AMENDMENTS TO THE DRAWINGS

REMARKS

Fig. 2 of Emerson

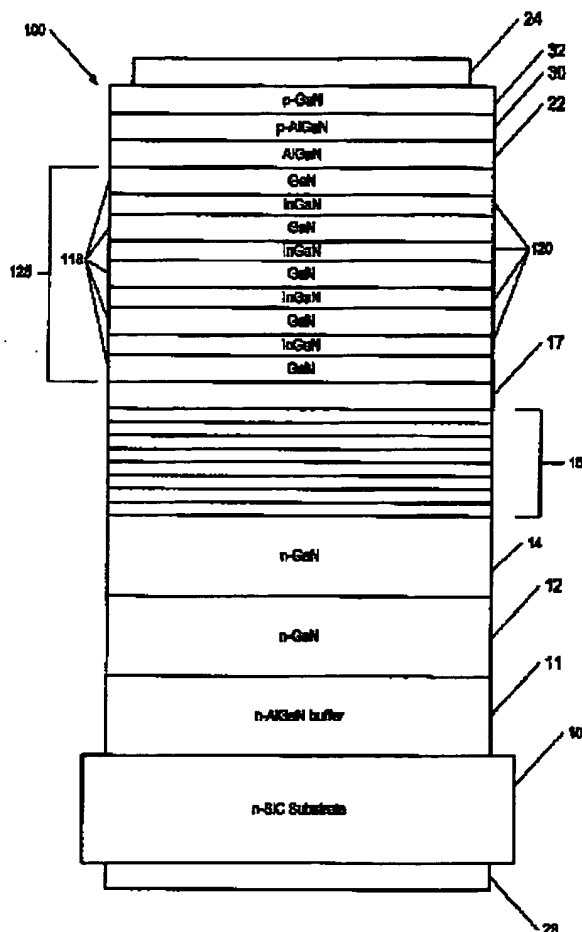
Emerson pertains to Group II based LED structures. In the Office Action, the Examiner points to Figure 2 of Emerson (reproduced below), which includes an SiC substrate **10**, a buffer layer **11**, superlattice layers **16**, barrier layers **118**, and an active region **125**.

Emerson fails to disclose or suggest $\text{Al}_y\text{Ga}_{1-y}\text{N}$. Emerson's buffer layer 11 is not $\text{Al}_y\text{Ga}_{1-y}\text{N}$ on a GaN-based buffer layer, but is rather an n-AlGaIn buffer layer (column 8, line 52) used as a conductive buffer layer (column 6, lines 55-56). As a result, these features of Emerson are fundamentally different from the $\text{Al}_y\text{Ga}_{1-y}\text{N}$ on a GaN-based buffer layer, as is set forth in the present invention.

That is, the claimed invention includes a first electrode layer **207** of an n-GaN layer formed on the upper $\text{Al}_y\text{Ga}_{1-y}\text{N}$ /GaN short period superlattice (SPS) layer **206**. In contrast, Emerson's lowest GaN of the barrier layer **118** functions to separate the barrier layer **118** from the quantum well layer **120** (column 8, line 62 to column 9, line 14). As a result, Emerson fails to disclose the claimed first electrode layer **207** of the present invention.

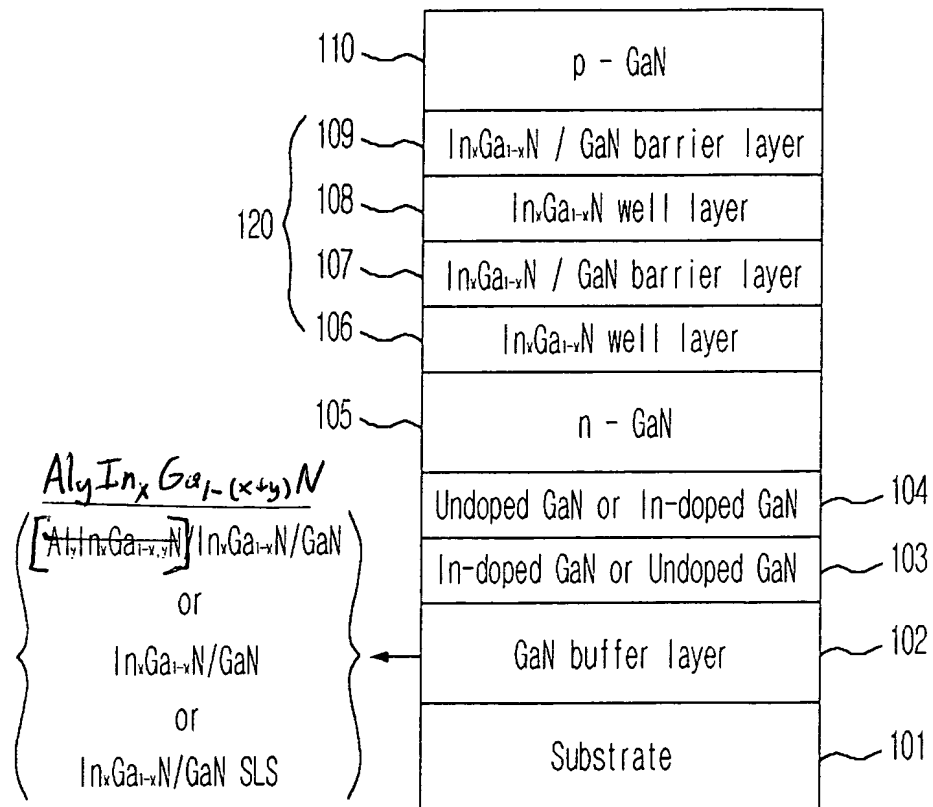
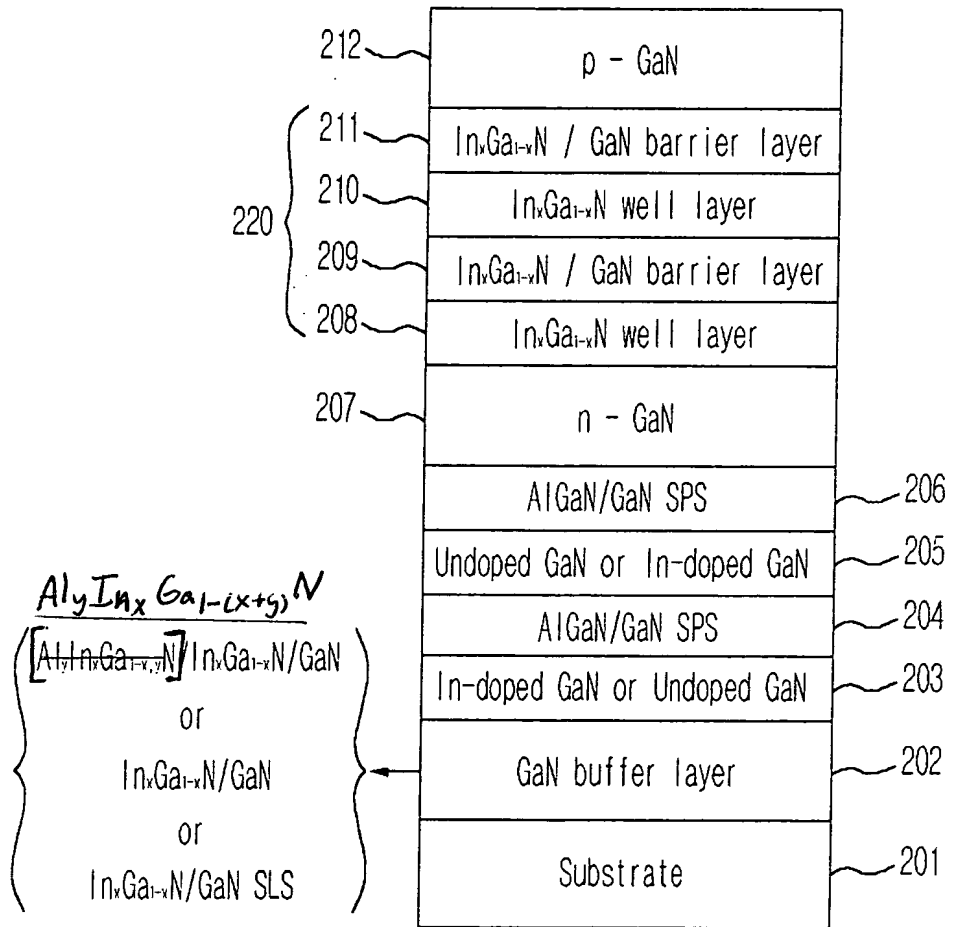
The attached sheet(s) of drawings includes changes to the formula for $\text{Al}_y\text{In}_x\text{Ga}_{1-(x+y)}\text{N}/\text{In}_x\text{Ga}_{1-x}\text{N}/\text{GaN}$ so as to correspond to the amendments to the specification.

The specification, claims and drawings have been amended to correct an obvious typographical error that would be clear to one of ordinary skill in the art. That is, one of ordinary skill would realize that the term " $\text{Ga}_{1-x,y}$ " has no chemical meaning and that the term " $\text{Ga}_{1-(x+y)}$ " was meant. As a result, no new matter is present in the application.
